June 4, 2010

**Response to questions in focal areas 1 – 4 - Anniedale-Tynehead NCP.**

**Figure 2.** Subject Class B drainage – Area 1.

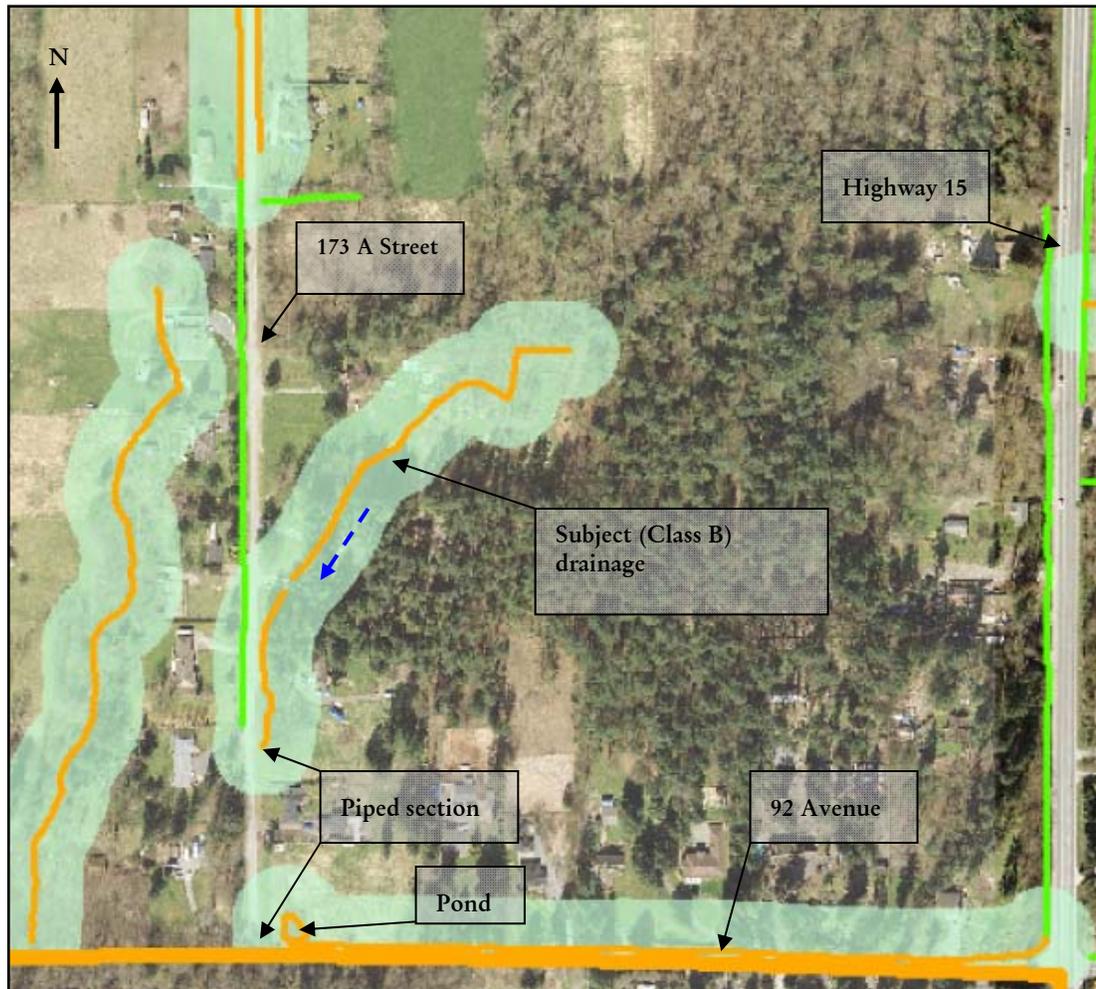
*Area 1. – What types of impacts will large format commercial development to the north of this riparian area (Class B) have on flow patterns and water quality? What type of mitigation measures may be needed to ensure that stream flow is not marginalized by development to the north (Roadway/Large Format Retail)? Is this riparian area likely fed by areas to the north? Can wildlife movement patterns be helped through ample street tree/greenway designs?*

We found evidence of a narrow, poorly defined channel in the moist, forested area to the northeast of 173A Street. Water flows to the southwest, but any natural channel system has been impacted by historical development along the eastern side of 173A Street. A very poorly-defined shallow swale parallels 173A Street, which suggests that the majority of water originating from the moist forest to the north east is piped underground. Numerous catch basins along the edge of 173A Street further suggest that water in this Class B drainage is piped (Figure 2).

Large-format commercial development to the north of this riparian area may impact both water supply and water quality, although specific impacts would depend upon the precise location of development footprints. Appropriate techniques should be employed during the development phase to ensure that stormwater emanating from the development area is properly managed. Specifically, paving large areas and promoting rapid conveyance of water into a stormwater system would result in substantially reduced flows in the summer and the higher incidence of peak flows in the winter, which could have deleterious implications on connected fish habitat (refer to response for Area 3 for more detail on stormwater management).

Mitigation measures should also be implemented that address water quality, given the potential for contaminants originating from the developed commercial area.

For example, catchment areas should be constructed that capture run-off from parking areas, to help minimize the introduction of hydrocarbons into drainage areas. Oil/water separators should be installed in drains to prevent the movement of hydrocarbons from the development.

**Figure 4.** Subject Class B drainage network – Area 2.

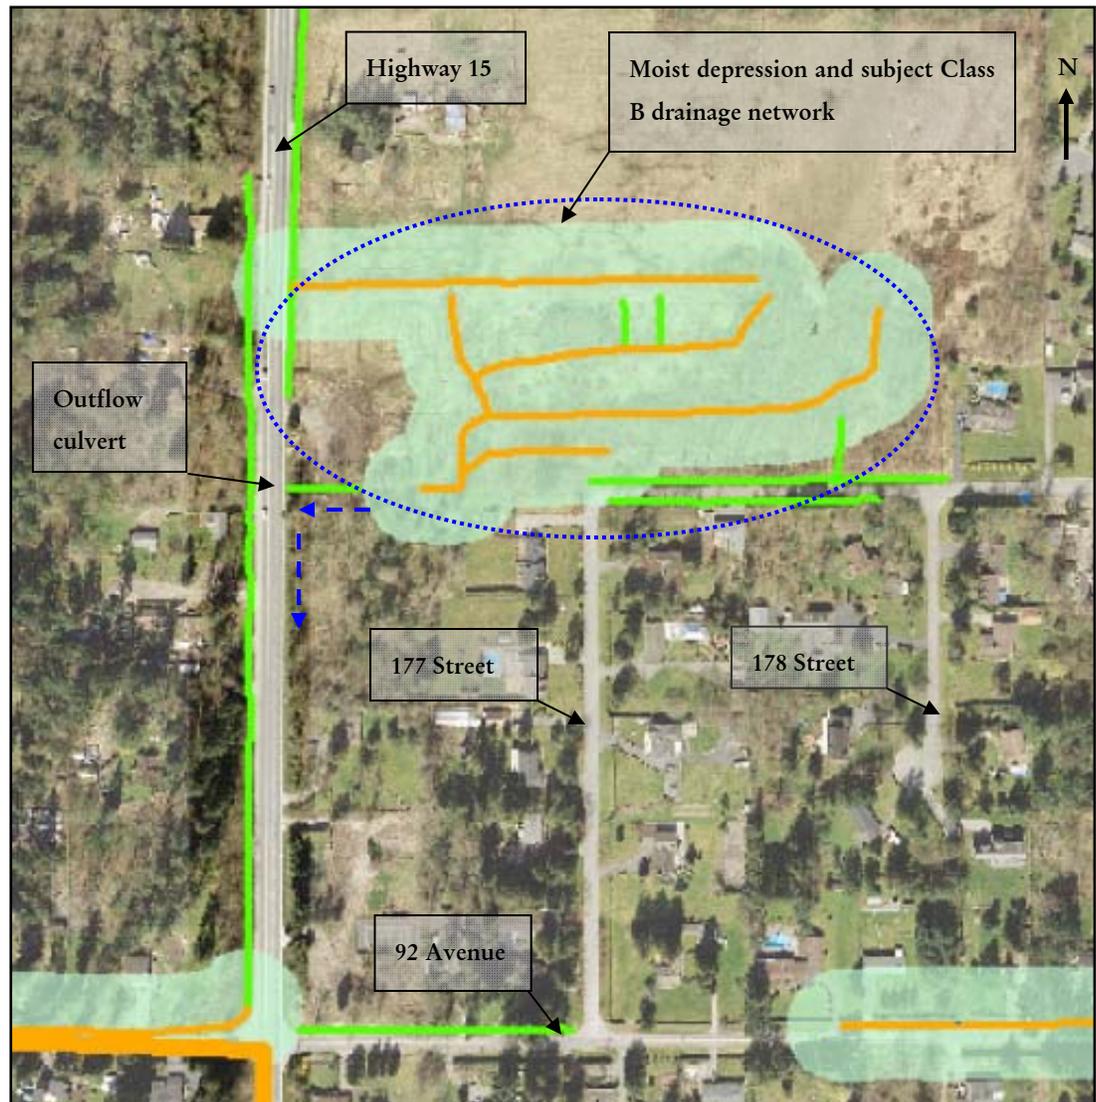
*Area 2. – With a high density residential land use in this area, it is unlikely that this riparian area will be maintained upon development. What areas would be best suited to compensate this ‘B’ Class riparian matrix, and in what form? Does this riparian area provide nutrients to any fish bearing areas in its current state? Where?*

The depression collects water on a seasonal basis, which drains to the west towards Highway 15. Drainage from the depression collects in a poorly defined swale, which connects directly to a culvert running underneath the highway (Figure 4).

Compensation for negative impacts to this area should focus on maintaining the function of the depressional area as a water retention zone. It will be difficult to quantify appropriate compensation for losses to fish habitat values, due to the lack of habitat attributes and probable lack of reasonable downstream benefits in the form of nutrient supply. Any future development in this area must ensure that water leaving the site is clean and that there is no net increase in stormwater flow. Maintaining water quality and managing stormwater flow should be addressed during both the development phase and post-development (over the long term).

Figure 5. Subject drainage network – Area 3.

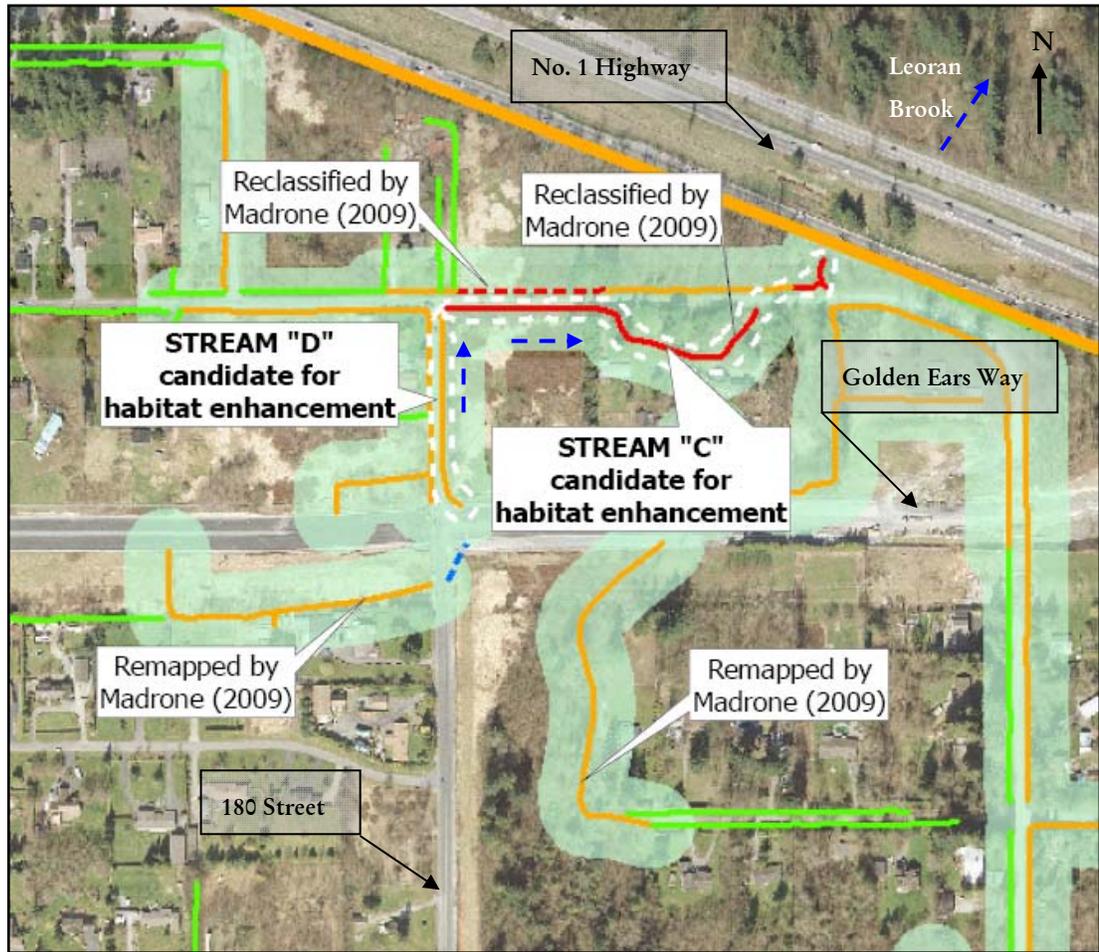
*Area 3. – This Class ‘B’ Watercourse flows into an area you have designated as an opportunity for enhancement, flowing into the Leoran Brook system, flowing into the Fraser. From your findings, do you consider this an important contributor of nutrients to streams further down the chain?*

While this “Class B” drainage currently resembles a ditch adjacent to 180 Street, it contains perennial flow and connects directly to fish habitat (the “Class A” drainage on the southern side of 96<sup>th</sup> Avenue) – Figure 5. With improved accessibility and habitat improvements (e.g. through riparian planting and/or improvement of instream diversity through LWD placement), it could be used by fish, at least on a seasonal basis.

Any development in this identified focal area must take into account potential impacts to water quality and water volume, given the proximity of fish habitat. The drainage that parallels the southern side of 96<sup>th</sup> Avenue is known to support fish, as does Leoran Brook. Development-related pressures must be mitigated, to ensure that impacts are identified and addressed.

One of the more obvious potential impacts is related to stormwater flow. Development activities typically result in a decrease in natural infiltration rates and increased stormwater runoff due to the increase in impervious surface cover. Peak flows in streams usually increase as a result of urban development (if not properly managed), which can have direct impacts on numerous fluvial processes, including sediment movement/deposition and bank stability. The frequency of very low summer flows is also increased as a result of an increase in the amount of impermeable surface cover. Proposed development in this area, therefore, must aim to achieve a “no net gain” in stormwater runoff.

Mitigation techniques regarding stormwater management may include installing bioswales, constructing rain gardens to capture storm run-off from roof tops, using permeable products for paved surfaces or constructing rock drains to encourage infiltration. An appropriately qualified professional should be involved from the planning phase when proposing development in this area to ensure that a site-specific stormwater management plan is designed and implemented.

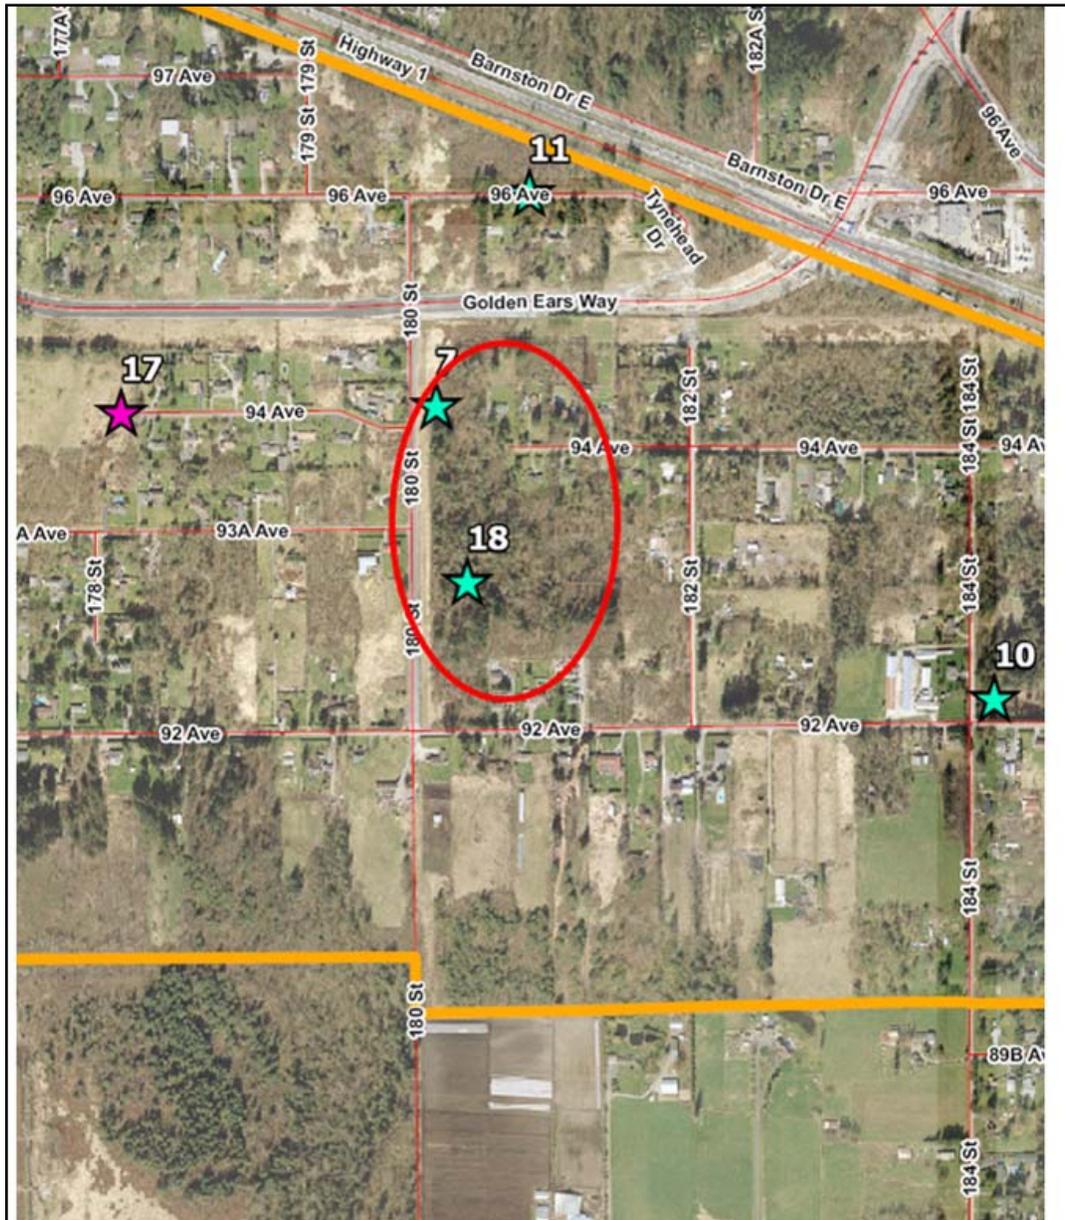
*Your findings indicated that this ecological hub was significant. Our land use plan identifies a cluster housing model within this area (approximately 60% built and 40% preservation). Would tree species and soil types in this area likely be able to withstand this type of development pressure? Are there any mitigation techniques that can be employed in this area to better maintain ecological/water quality health?*

The ecological attributes in Area 3 – Figure 6 - (e.g. vegetation cover, wildlife trees and other significant mature trees) can be maintained with 40% retention if appropriate planning is employed. Development plans should identify wildlife trees and other significant trees and maintain large patches of vegetation (15 m to 20 m diameter or greater). If possible, these wildlife patches should be composed of an even mixture of coniferous and deciduous species in an unevenly aged distribution. The wildlife patches should include berry producing tree and shrub species (e.g. salmonberry – *Rubus spectabilis*, red elderberry – *Sambucus racemosa*, thimbleberry – *Rubus parviflorum*, red huckleberry – *Vaccinium parvifolium* and bitter cherry – *Prunus emarginata*) and wildlife trees, as these promote bird activity and species diversity. Wildlife trees and course woody debris left on the ground are beneficial to numerous wildlife species.

In the built portion of the site, significant mature trees should be identified and retained if possible. Other trees destined to be cut should be topped to retain the snag for the production of future wildlife tree habitat, assuming the remaining snag is not a safety hazard.

In addition, the biological function of the wildlife patches will be improved by buffering the retention areas by planting a dense layer of native shrubs that discourages human and dog encroachment and provides cover and protection to wildlife and birds. Retention areas should be connected by properly designed travel corridors as discussed in Area 1.

Figure 7. Subject drainage network – Area 4.

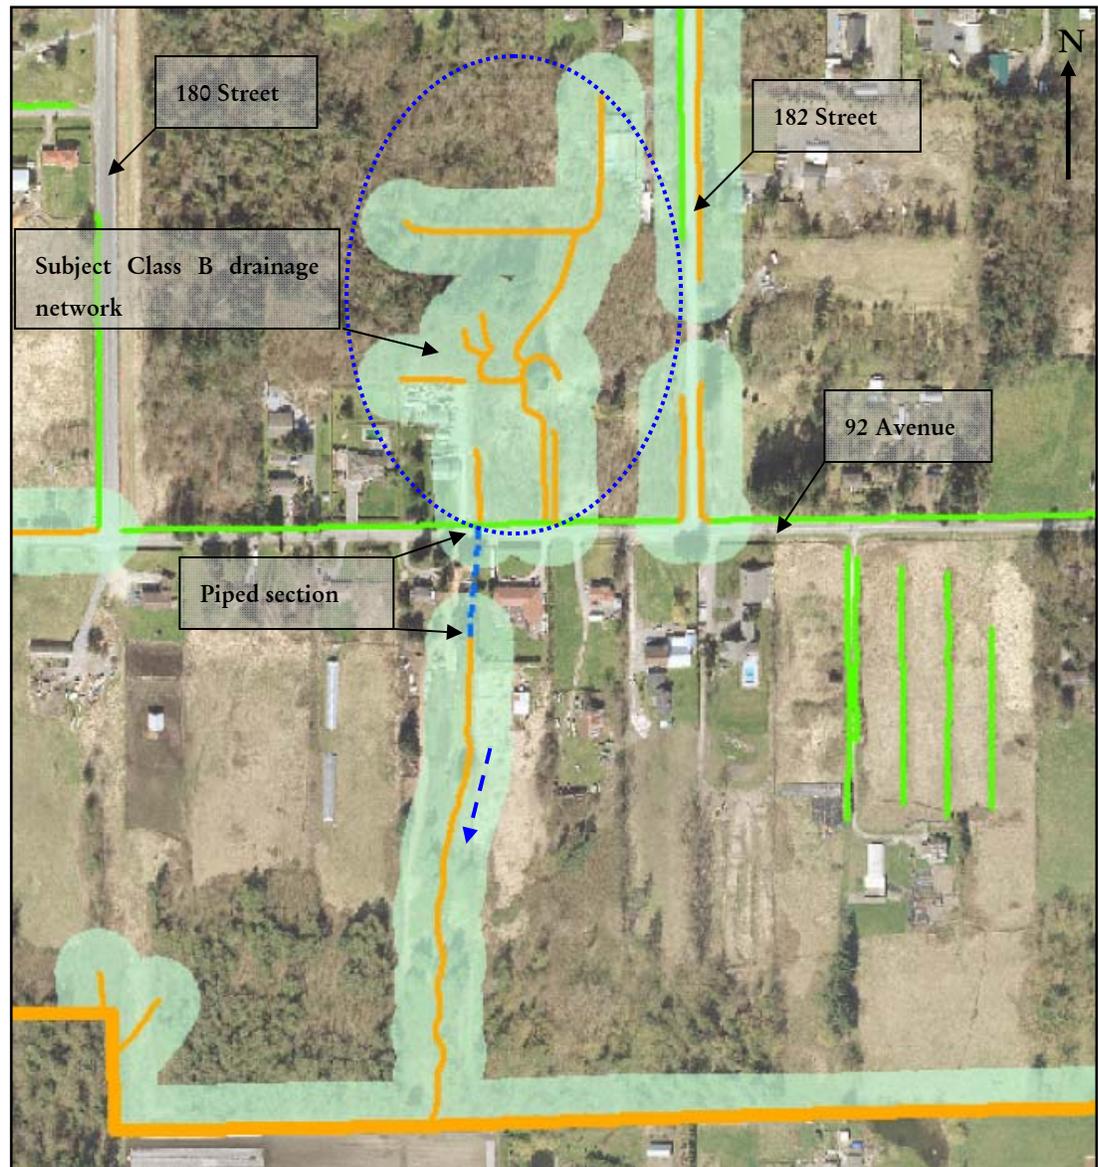
*Area 4. – Upon aerial inspection (high definition aerial photos), this area appears to contain a matrix of water courses / ditches and small dykes. The drainage/soils in this area seem quite limited. What type of limitations would small lot medium density housing development have in this area? Do you imagine significant fill required to develop this area would impact drainages to the south significantly?*

Area 4 represents a catchment for water that flows to the south and connects with the Class B drainage on the southern side of 92<sup>nd</sup> Avenue. Water draining from the site is piped from the southern side of 92<sup>nd</sup> Avenue, although it becomes daylighted again, as part of a natural system that connects with a “Class AO” system to the south (Figure 7).

Development in Area 4, especially if significant fill is required, would likely lead to an alteration of the existing drainage pattern. Fish habitat located downstream may be adversely impacted, given the connectivity of the Class B drainage to the south of 92<sup>nd</sup> Avenue with seasonal fish habitat.

Again, the goal of the development process must be to properly manage stormwater run-off, which will help to avoid negative impacts associated with increased peak flows and reduced summer flows in connected systems. Mitigation measures for both stormwater management and water quality for this area should follow the same general techniques listed previously. More detailed fieldwork may be required prior to the development phase to properly identify the main water conveyance zones and water retention areas.
